World Forum for Harmonization of Vehicle Regulations**Working Party on Passive Safety****Sixty-sixth session**

UN Regulation No. 16 (Safety-belts)**Proposal for Supplement 6 to the 07 series of amendments
and for Supplement 1 to 08 series of amendments to UN
Regulation No. 16 (Safety-belts)****Submitted by the expert from the International Organization of Motor
Vehicle Manufacturers***

Annex 19 - Appendix 1

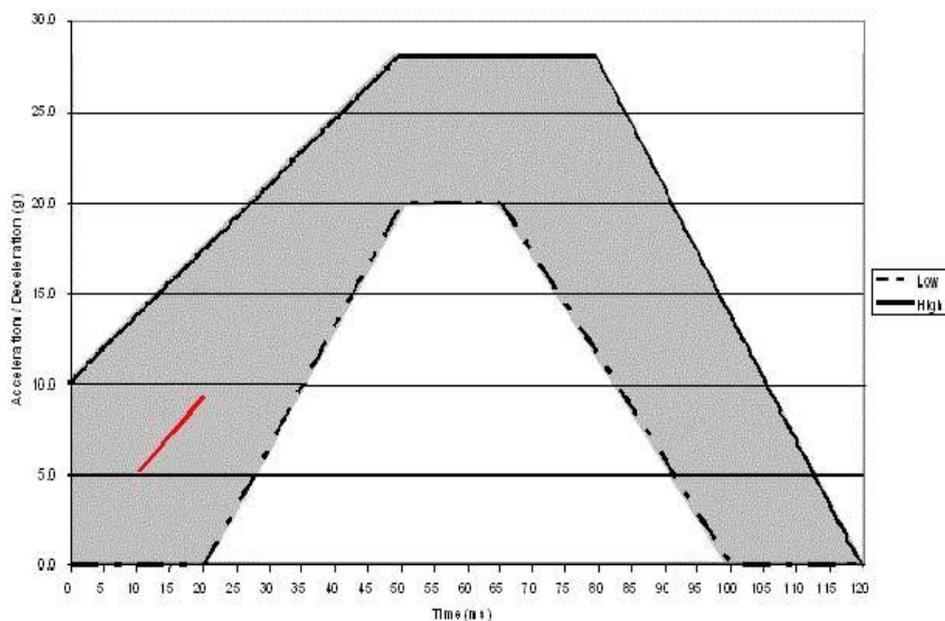
Insert new Annex 19, to read:

Description of curve of trolley's deceleration or acceleration and test devices (CRS)

Frontal impact, curve of trolley's deceleration or acceleration, as function of time

Frontal impact – Test pulse 1

<i>Definition of the different curves</i>		
<i>Time (ms)</i>	<i>Acceleration (g) Low corridor</i>	<i>Acceleration (g) High corridor</i>
0	-	10
20	0	-
50	20	28
65	20	-
+80	-	28
100	0	-
120	0	-

The additional segment applies only for the acceleration sled."
